EXISTING PART D990443

MODIFIED TO HOLD DOWN
 TELESCOPE MIRROR BOX

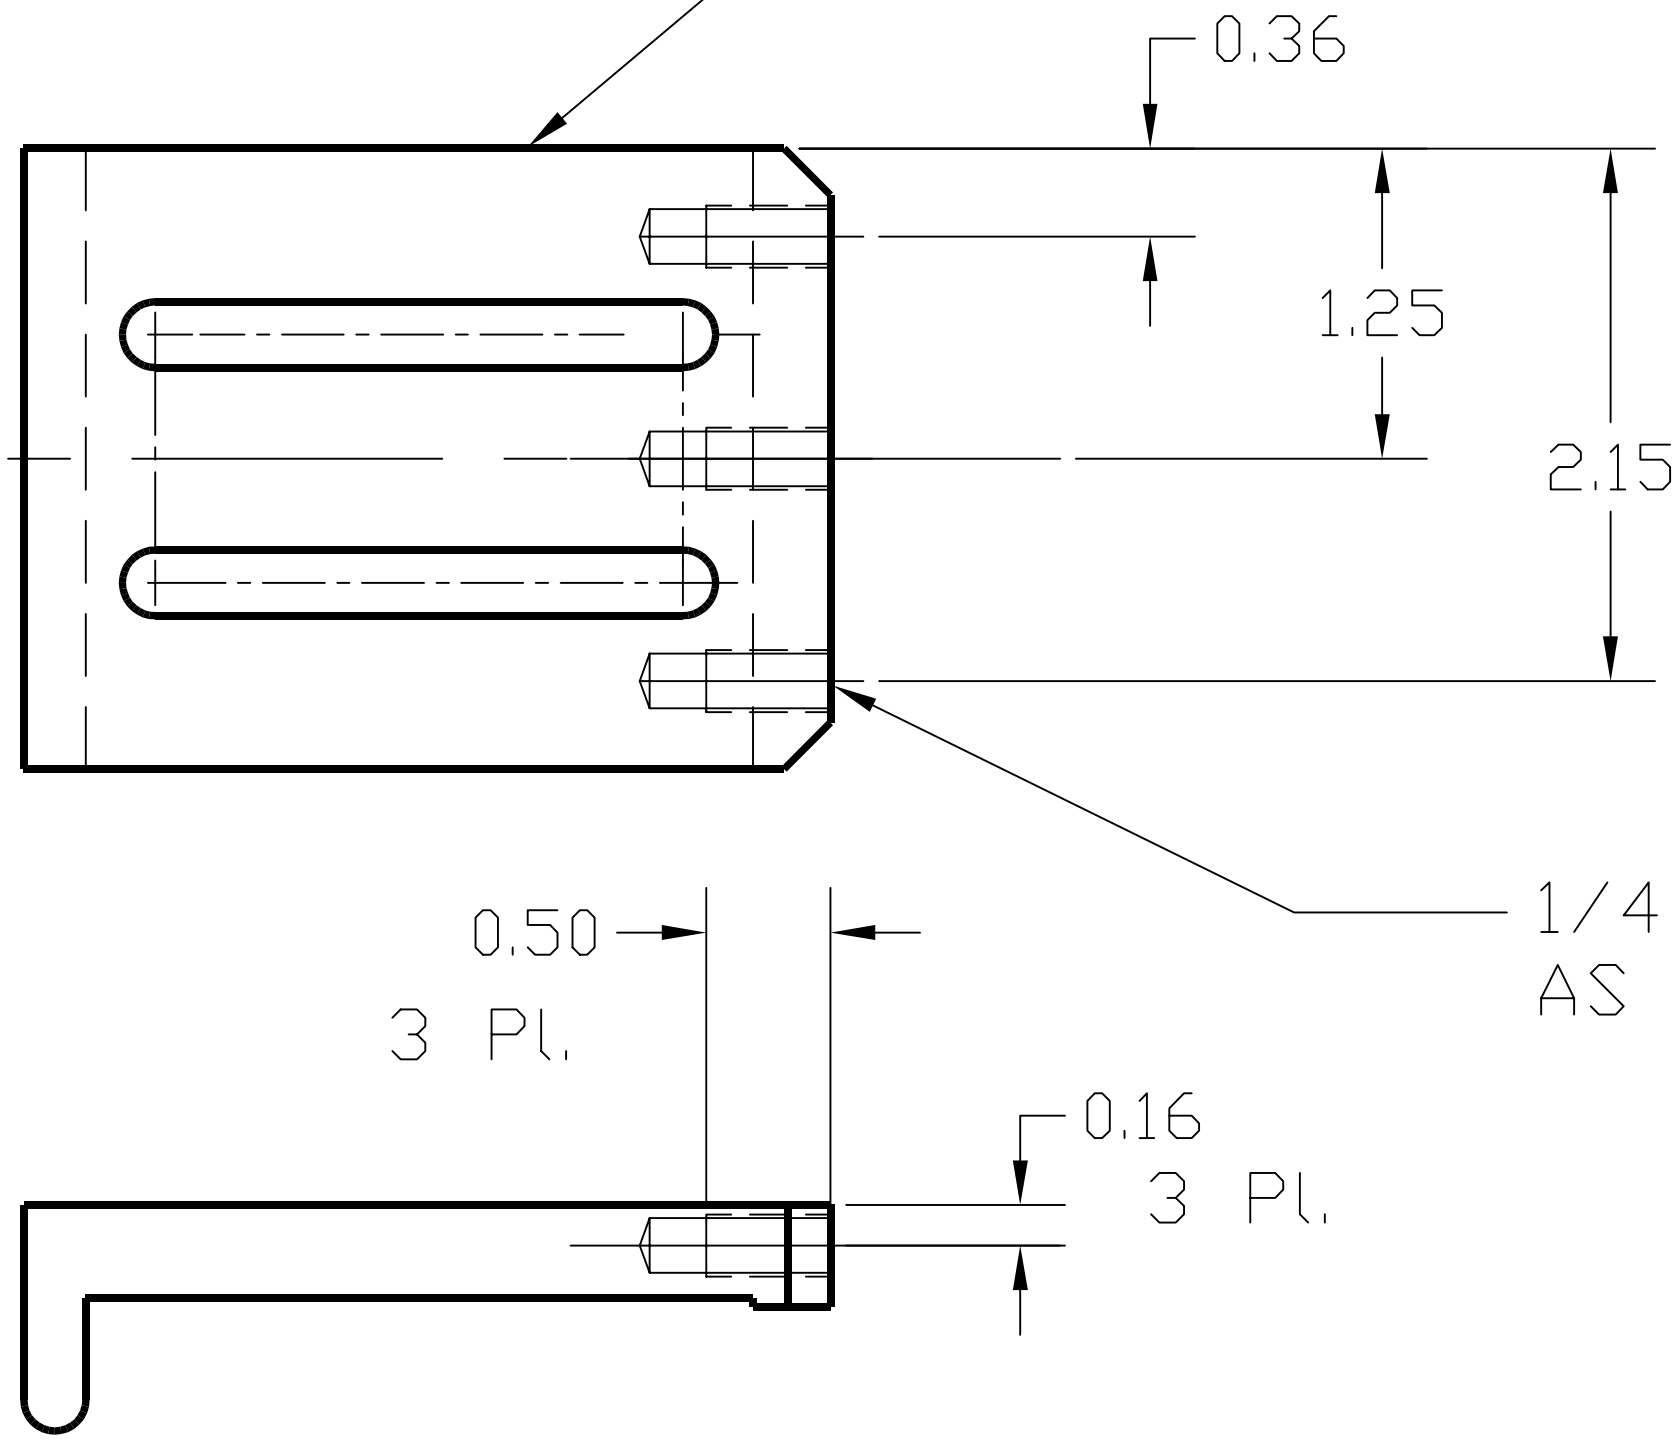
~~Liquid contaminants/Machining Lubricants~~
 Liquids containing hydrocarbons or other contaminants, other than the machining fluids specified herein, shall not be allowed to come into contact with suspension material at any time. All machining fluids shall be water soluble and free of sulfur, chlorine and silicone; such as Cincinnati Milacron's Cimtech 410 (stainless steel).

~~Identification Serial Number~~
 A serial number shall be etched, or scribed on the part see note drawing note.
 Serial Number Format
 The Serial number shall be of the format:
 D99xxxx-x - 001
